Errata Sheet MB86295 Coral P

Errata List:**Jan., 02 2006**

15-1. Coral = PCI Master.

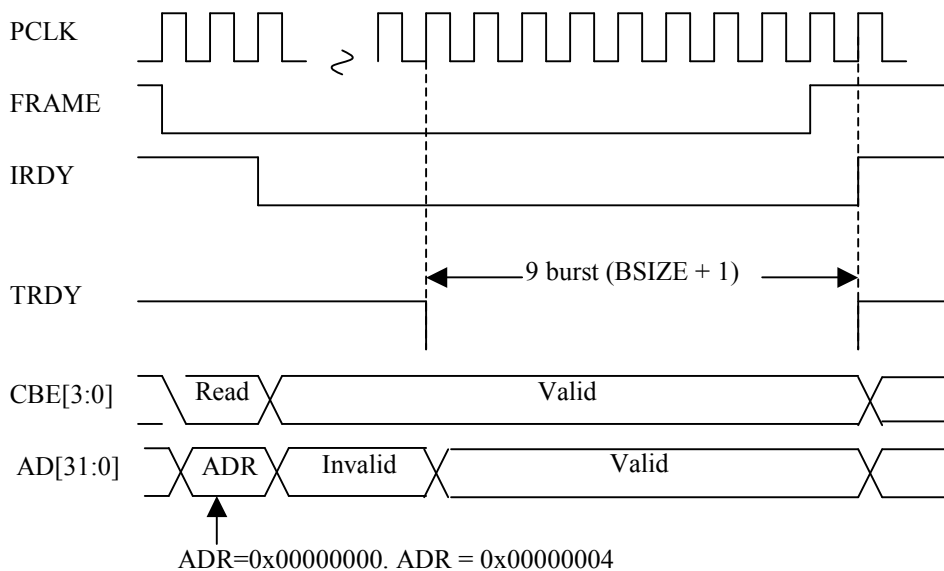
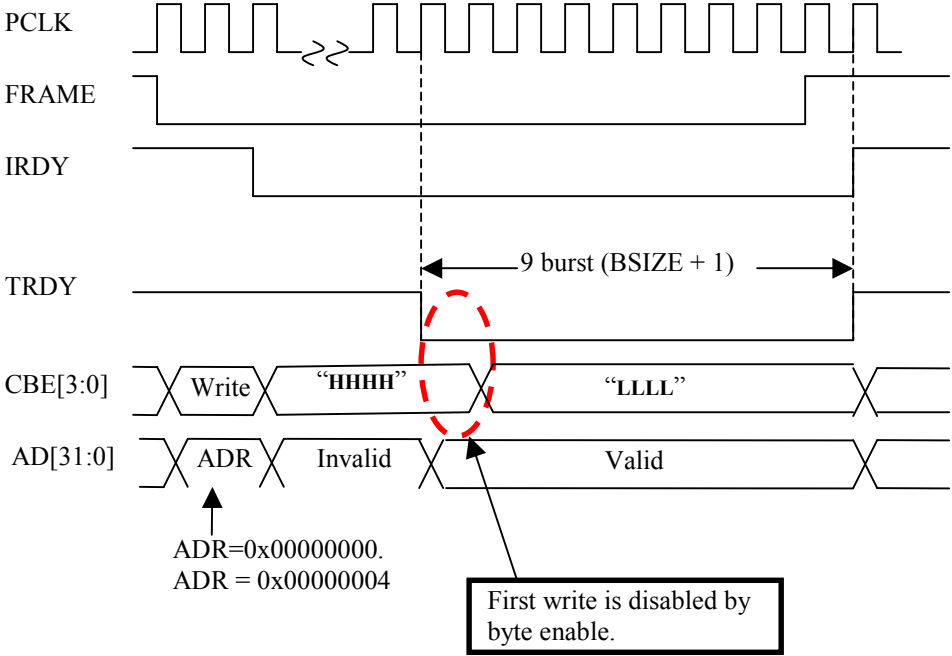
Coral can't issue an odd address to PCI area.

If Coral is the master device and the beginning address is set to the odd address in 64-bit boundary, Coral issue the previous even address.

In Coral master read mode, Coral begins to read the previous even address and read the setting of burst size(BSIZE of BCR) plus "1".

In **Coral master write mode**, Coral begins to write the previous even address with disable write byte enable and write the setting of burst size(BSIZE of BCR) plus "1".

15-2. Coral = PCI Slave.

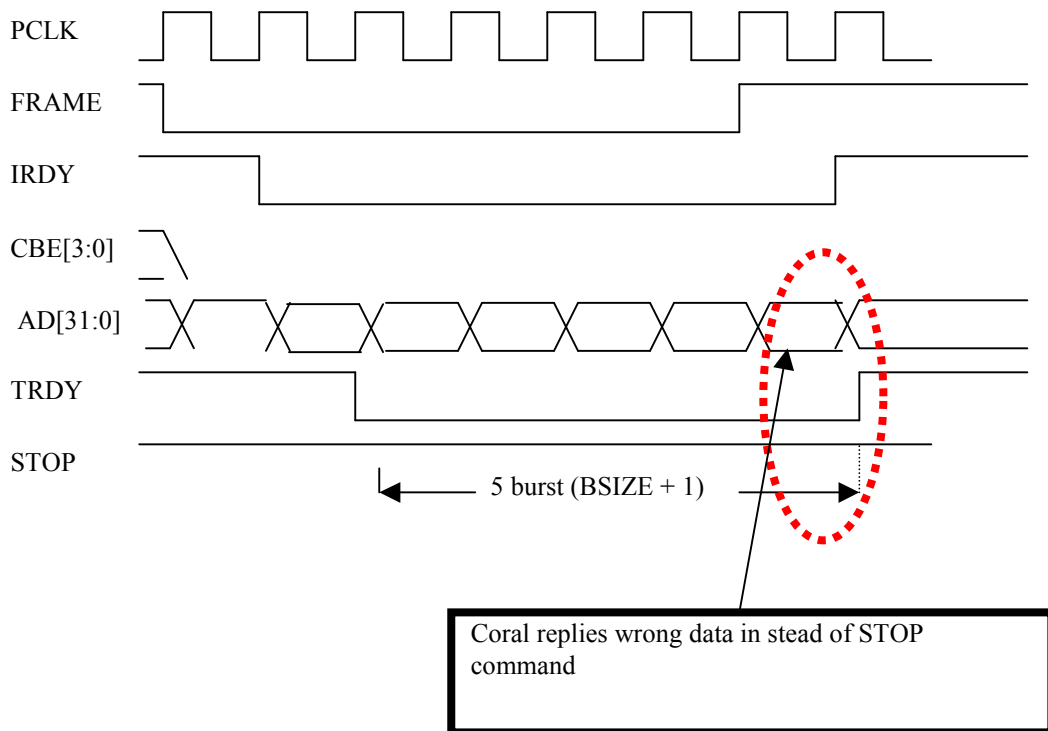
Coral reply the wrong data, if the read burst size comes more than the setting of SRBS.

This phenomenon occurs only burst read.

Coral replies the retry until storing the SRBS size data to Coral's PCI internal buffer.

After stored the data, Coral begins to reply the data by TRDY. But if the burst read comes more than the size of SBRBS, Coral replies the wrong data instead of issuing the STOP.

Figure 1 synchronising the access to the Coral

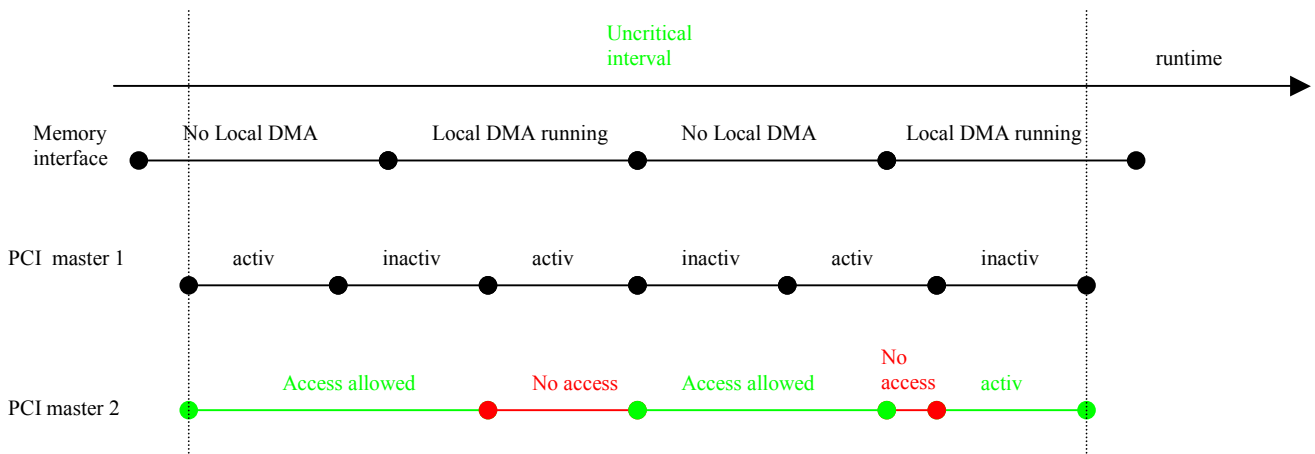
The Coral can fail in case of multi master access and a local DMA are running at the same time.

- (1) Two PCI masters access Coral-PA via PCI bus. One master (Master-A) writes data to the memory which connected to Coral-PA. Another master (Master-B) reads data from the Coral-PA. These two transactions are executed independently and simultaneously. The problem does not occur, if both master are reading or writing to the Coral.
- (2) The "Local Display List" transfer and rendering operation are initiated at the same time.

Because of the two independent data transfer from PCI master-A and B, it happens that write transaction from master-A occurs just after RETRY response of PCI from Coral-PA for the preceding read transaction of master-B. In certain condition of internal timing of Coral-PA among above transaction occurring, the write transaction by Master-A fails as the phenomenon that the data is written to different address intended (wrong address is used for the write transaction). In this problem, the wrong address value was swapped from the series of the data originally intended to store the memory. Therefore, the value of the wrong address is random value in general.

The access to the Coral must be synchronised.

Local DMA and multi master access may not occur at the same time. A single master access during a local DMA is running does not evoke the problem.
